### STAFF RECOMMENDATION

1414 Calvin Avenue

November 19, 2018

**Description of Project:** Application is to construct a rear addition that is wider than the historic house.

2
**RIGHT SIDE ELEVATION**  
 A-3.000 SCALE: 1/8" = 1'-0"

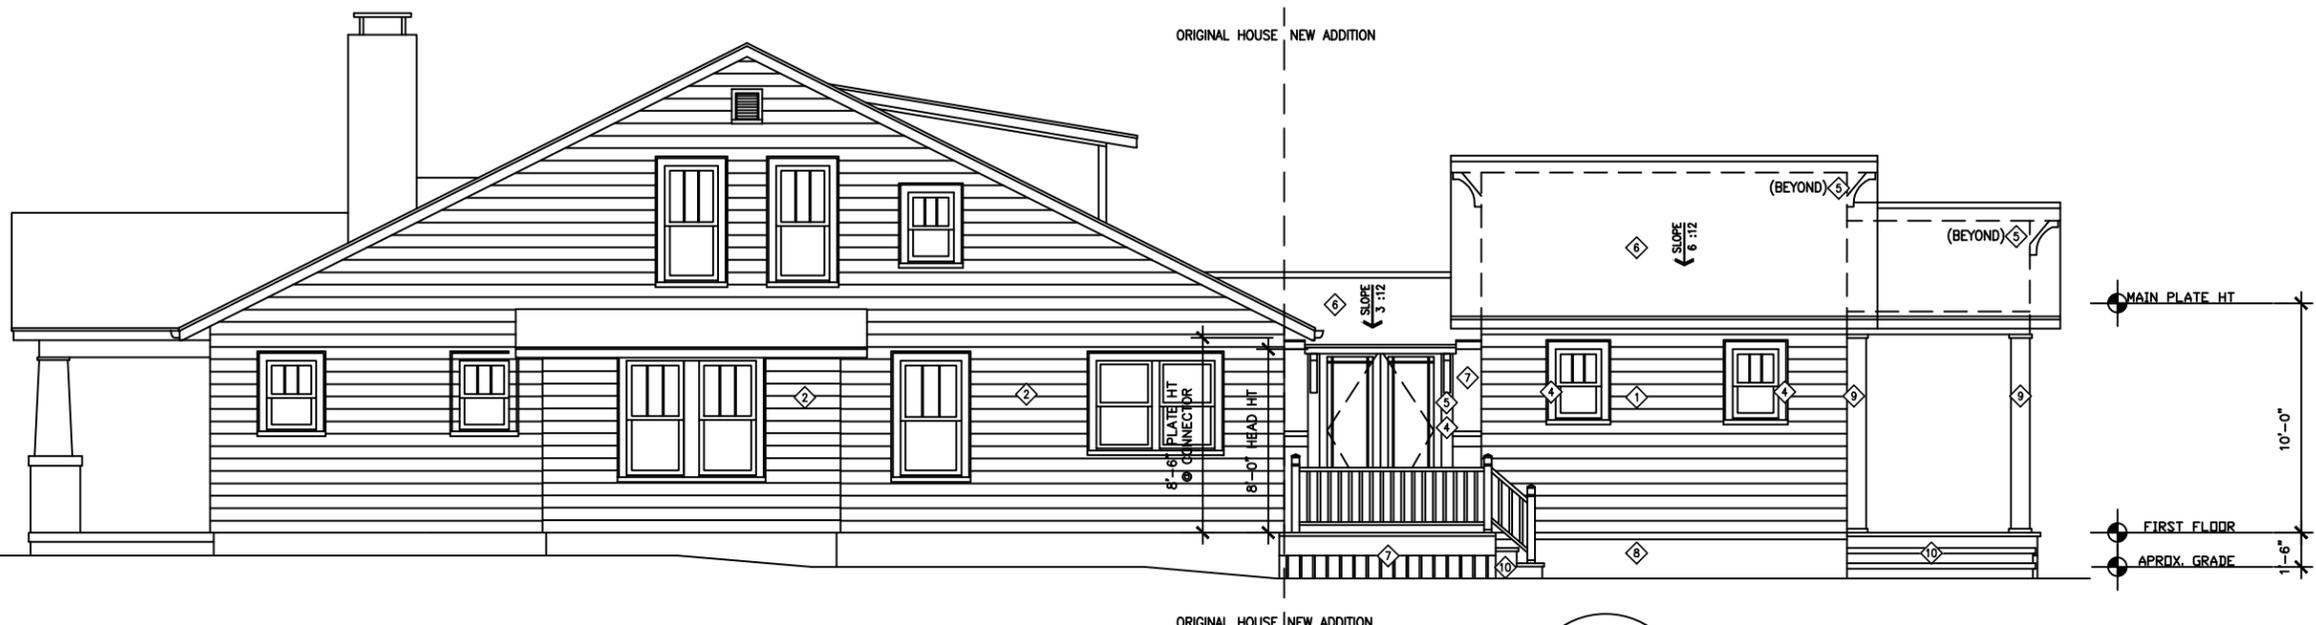
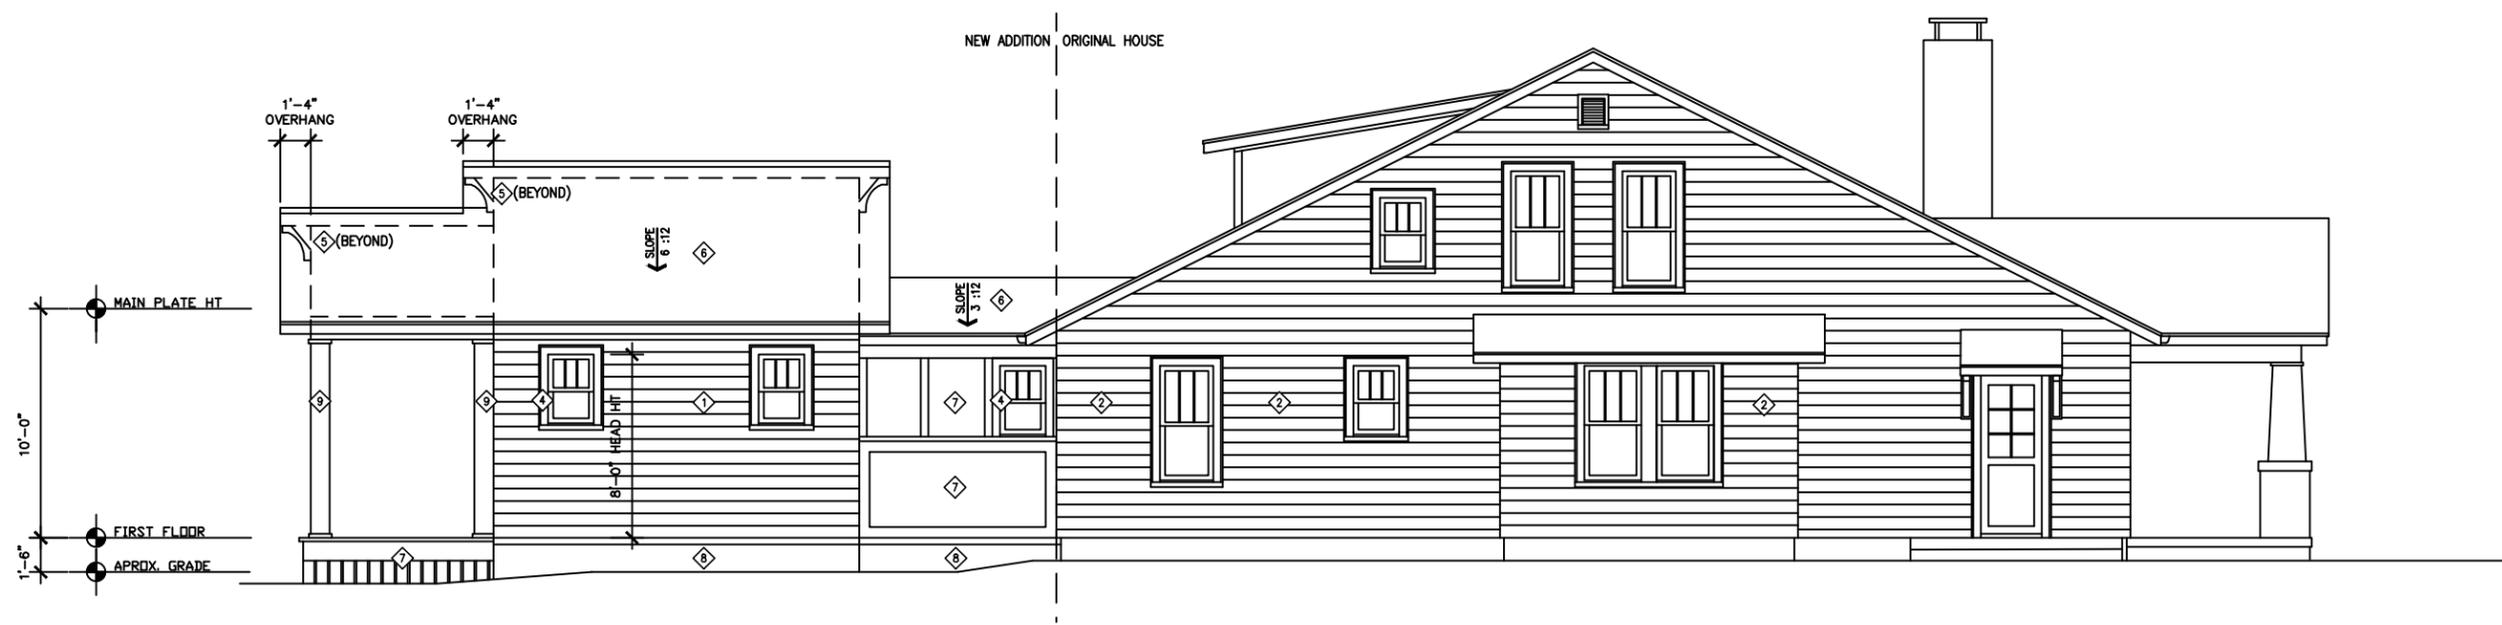
Height & Scale: The ridge height of the proposed addition is about seventeen feet (17') high, which is about six feet (6') lower than the ridge height of the house, at approximately twenty-three feet (23') high. The eave heights will match the height of the historic eaves, at approximately nine feet (9') tall. The depth of the addition is about thirty-two feet, ten inches (32' 10") deep while the house itself is currently about forty-seven feet (47') deep, inclusive of the front porch. The last eight feet (8') of the addition comprises a rear porch which will be open and help to lessen the impact of the depth of the addition. The overall width of the addition is about twenty-five feet (25') at its widest, as opposed to the thirty foot (30') wide house. The one story addition adds about five hundred-ninety (590) square feet to the one-thousand-four-hundred-thirty (1,430) square foot house.

Roof form: The historic house has a side gabled roof with a slope of 6/12 and a shed dormer on the rear. The proposed addition will use a rear gabled roof form, both in the low connector and as the primary roof. The rear porch will also have a projecting gabled roof. The slope of the connector will be 3/12 while the main roof and porch roof will have a 6/12 slope. Staff finds these roof slopes and forms to be appropriate and to meet Sections II.B.5. and II.B.10. of the design guidelines.
